Preliminary responses to OEH and SEWPaC comments on the Preferred Project
Report and Response to Submissions — biodiversity (26 March 2013)

Re: Cobbora Coal Project – Preliminary Responses to OEH and SEWPaC Comments on the Preferred Project Report and Response to Submissions – Biodiversity

DATE: 19/3/2013
MEMO TO: Department of Planning and Infrastructure – Stephen O’Donoghue
FROM: Gavin Heydon
SUBJECT: CLARIFICATION OF TAILINGS INFORMATION
REFERENCE:

The purpose of this addendum is to correct the results presented in Appendix E that were affected by a water balance model error, and to discuss the wider implications of the error for the Surface Water Assessment and Environmental Assessment. In addition, further information is provided in the addendum on additional model sensitivity analyses undertaken to address a concern of the DP&I's reviewer regarding the reliance of the mine on the surface water entitlement from the Cudgong river source. Specifically, the reviewer raised the concern that the volume of groundwater inflow to the mine pits available for use in the mine water management system may have been overestimated.

Figure B.4 – Sum of simulated daily storages in all mine pits for mine stage year 1 and 10th percentile rainfall (dry) year of 1967

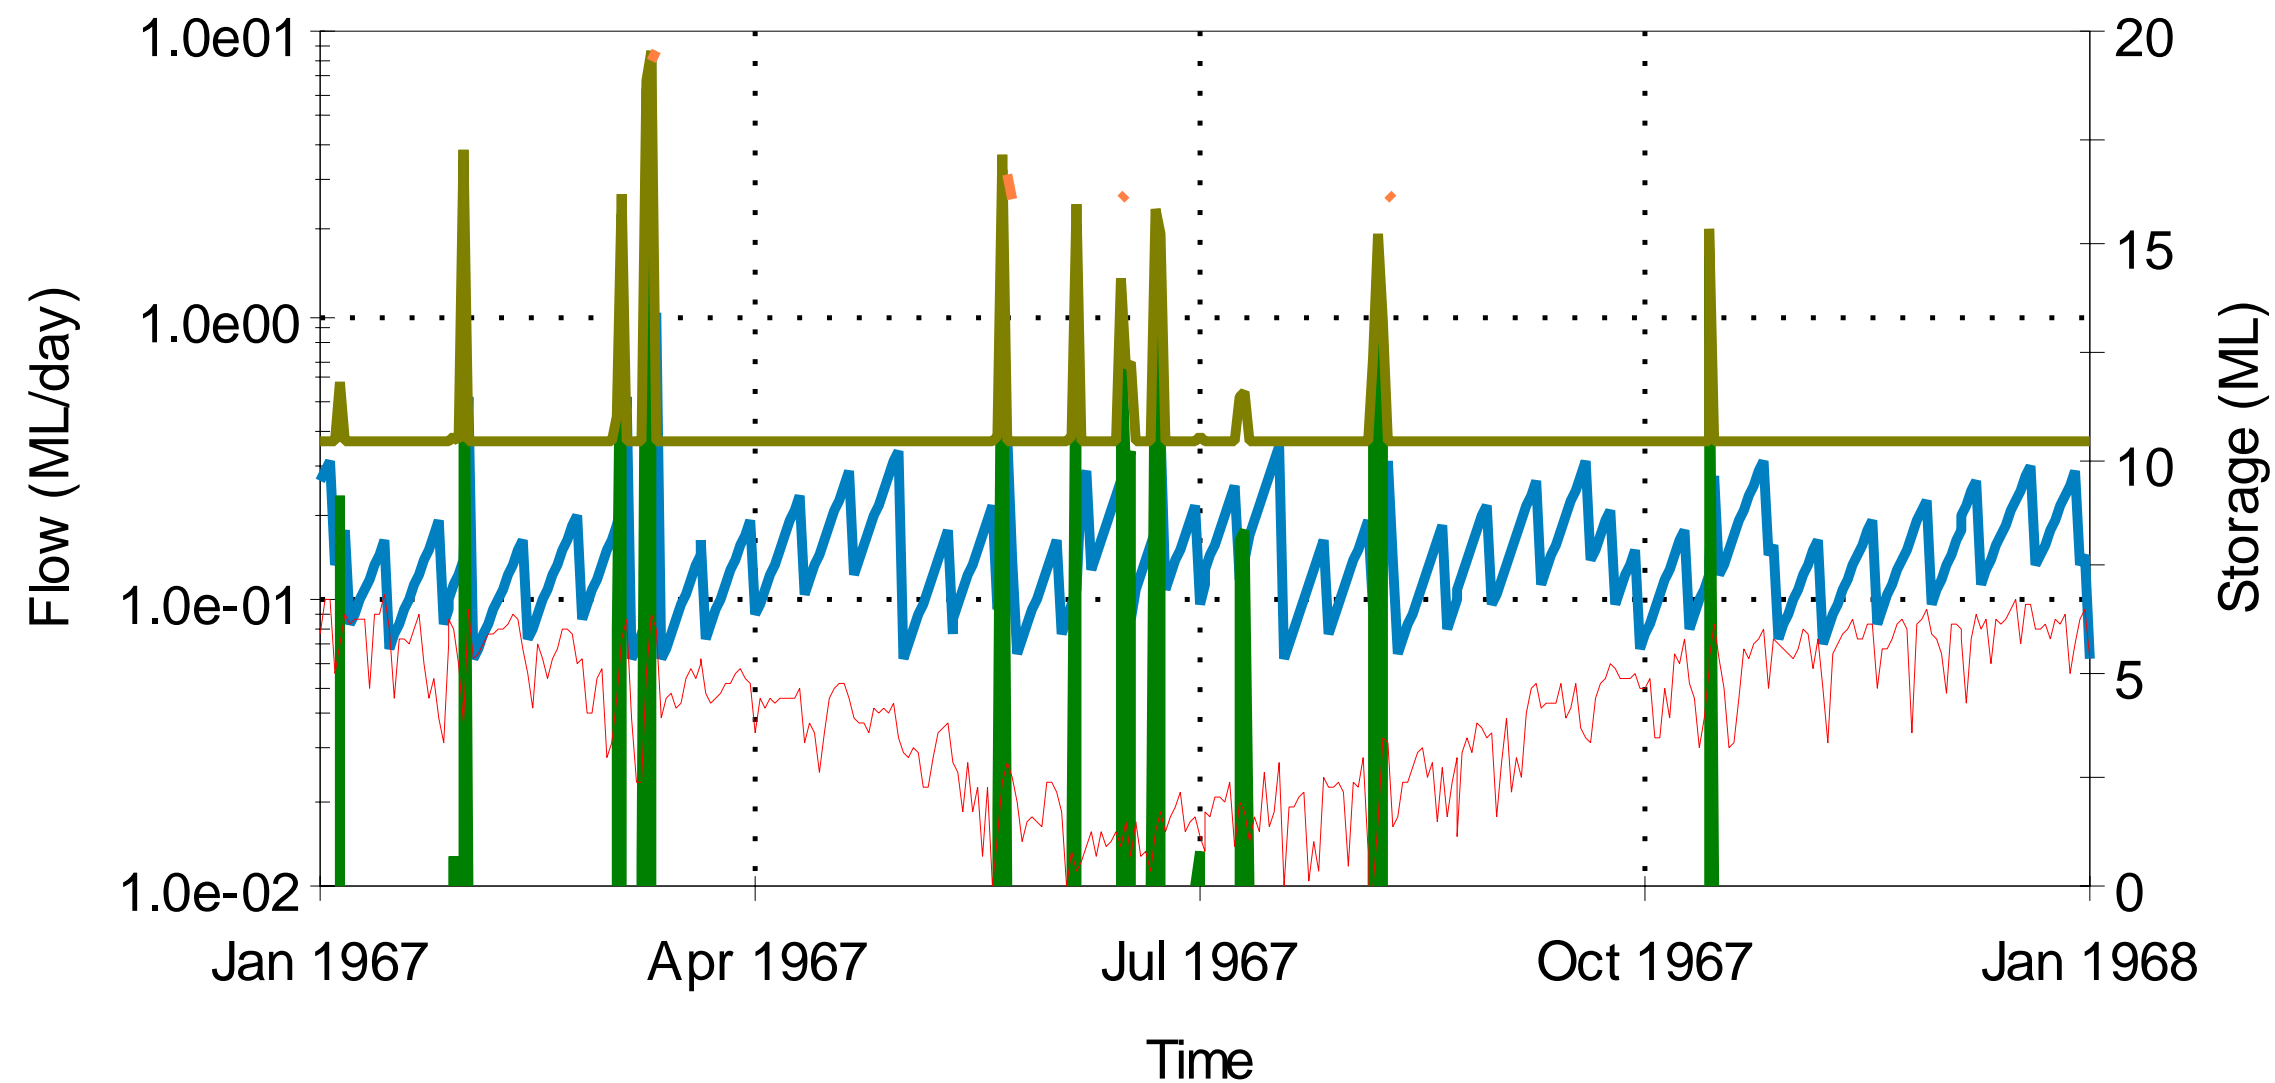
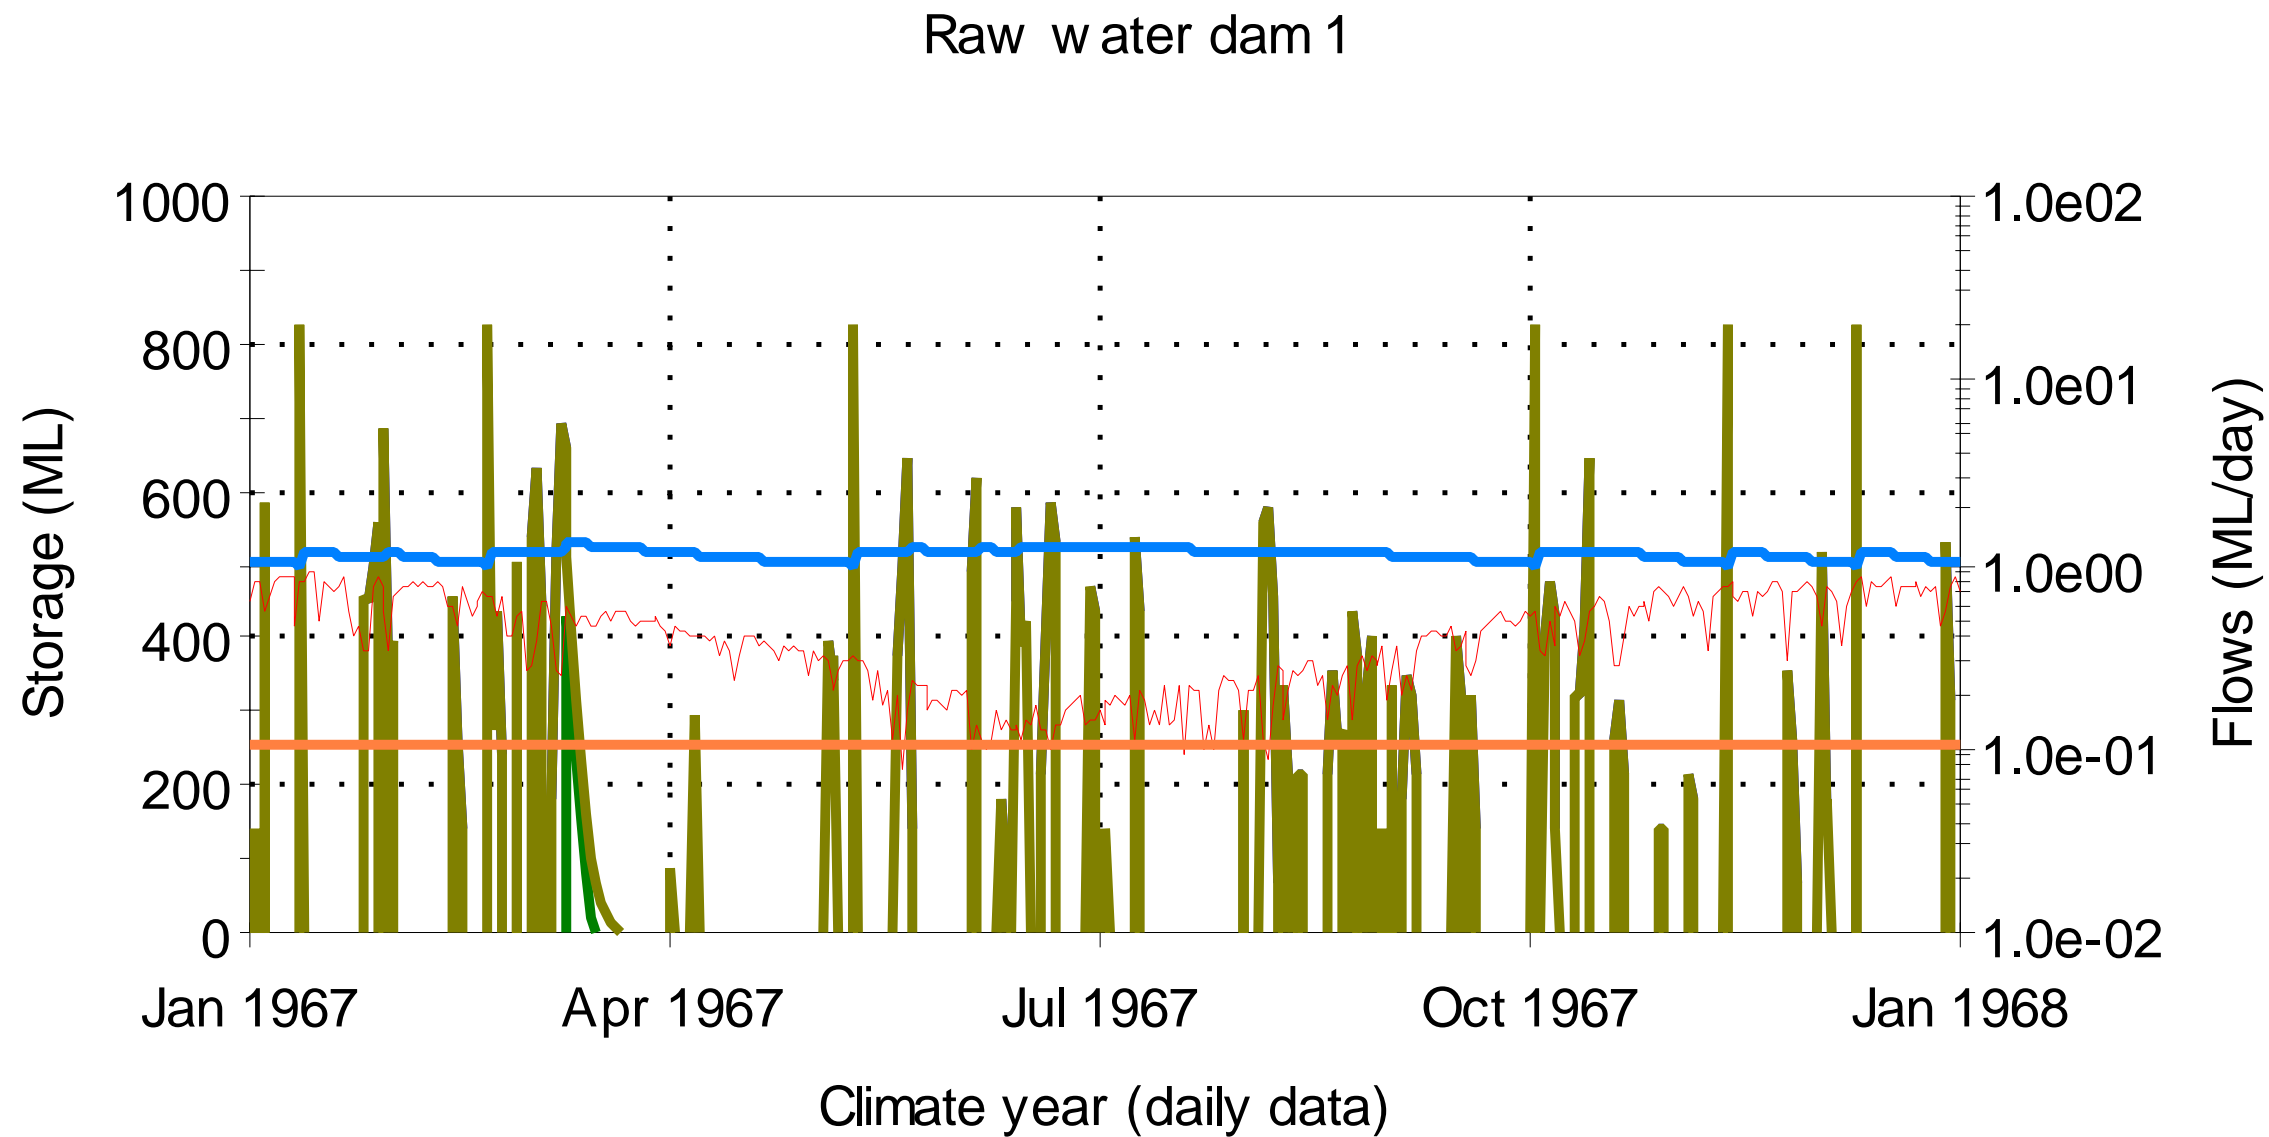
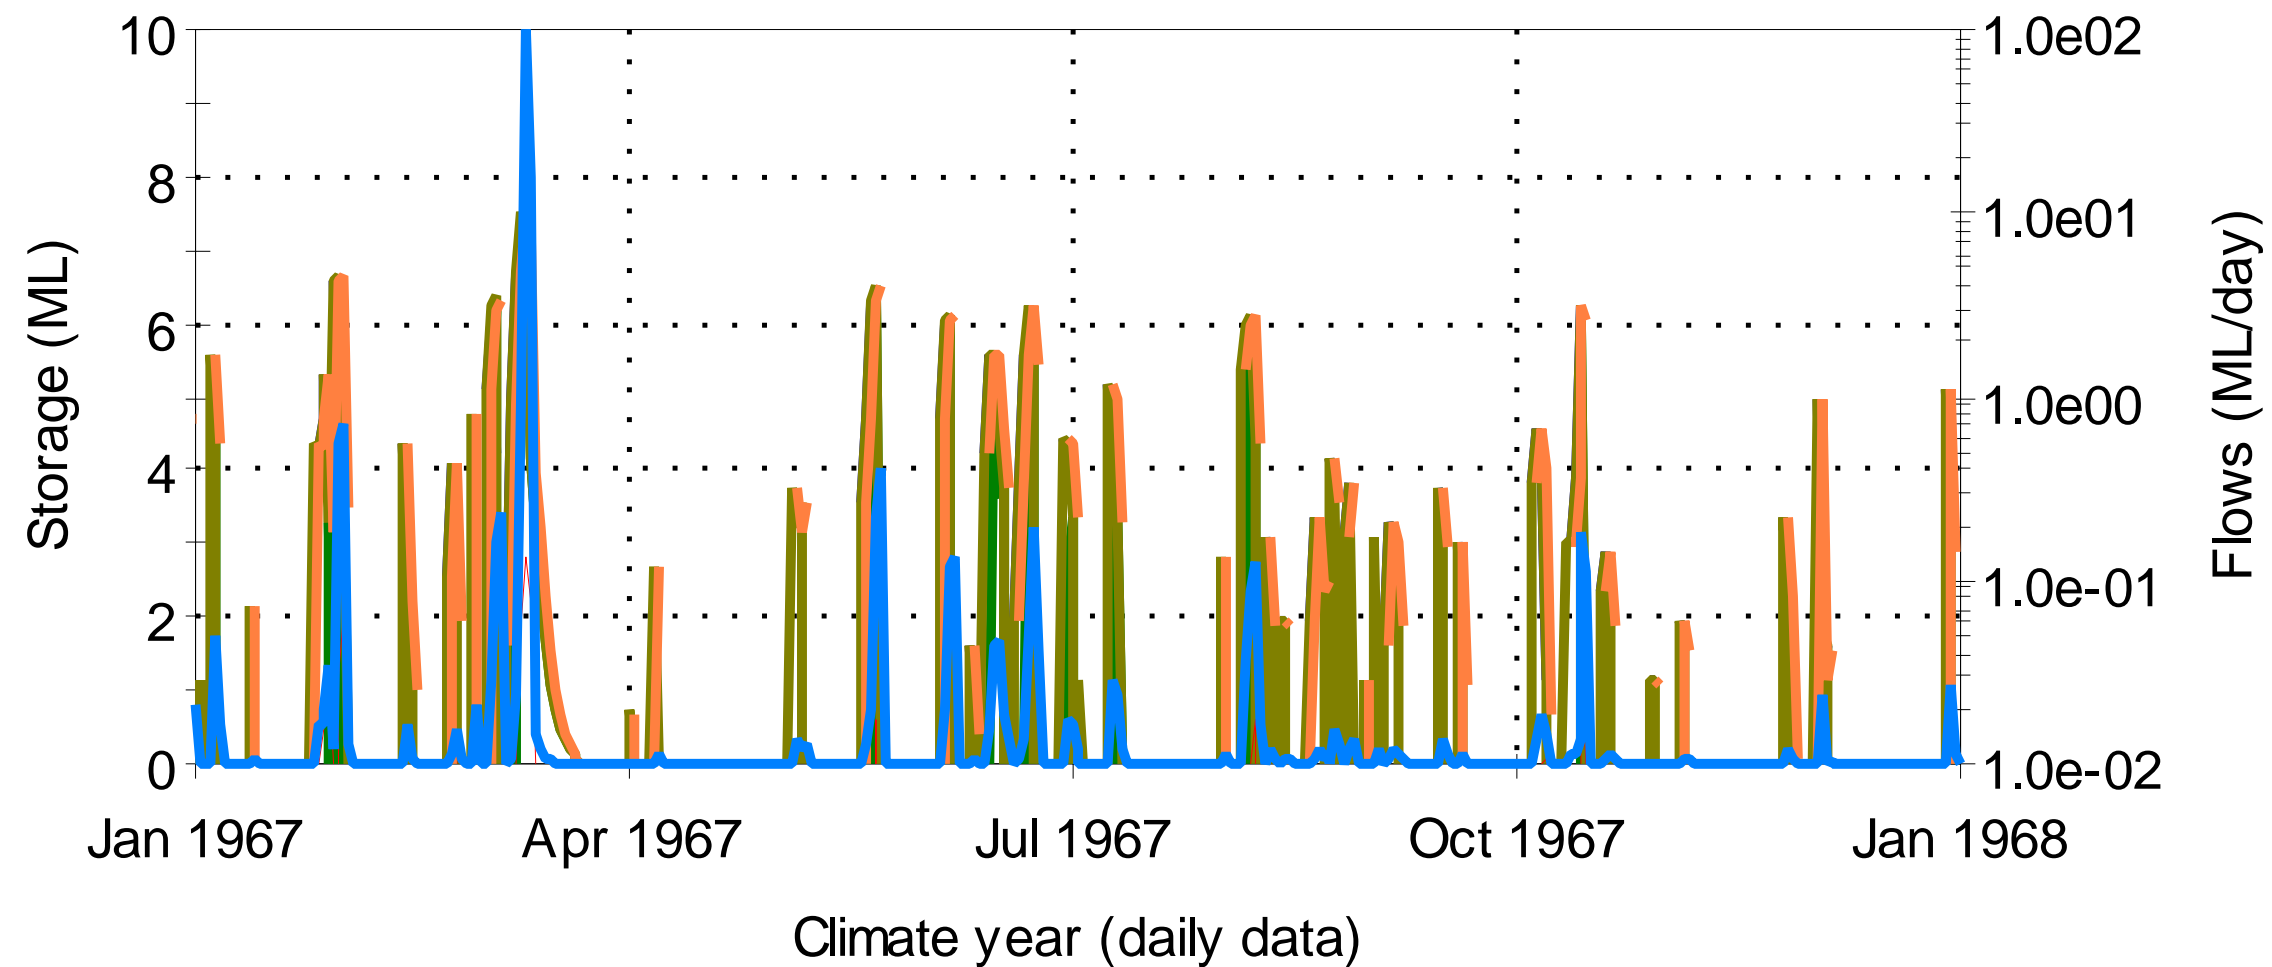
Additional figures are presented in Appendix B to demonstrate the water balance for the different types of dams in the GoldSim model. The figures are based on Year 1 of operation and demonstrate that the project dams build up storage in the system within a year of operation. Figure B.1 provides an overview of the water balance in all dam types for the entire simulation. Figures B.2 to B.6 provide water balance results for the mine water dams, sedimentation dams, pits, the raw water dam and tailings dams for mine stage year 1 and the 10th percentile rainfall (dry) year of 1967. While not all time series results are easily visible on the charts, the main purpose of the figures is to demonstrate the variation in storage within the different dam types throughout the 10th percentile (dry) year, and the initial and final storages at the start and end of the year. More detailed results can be provided if required.
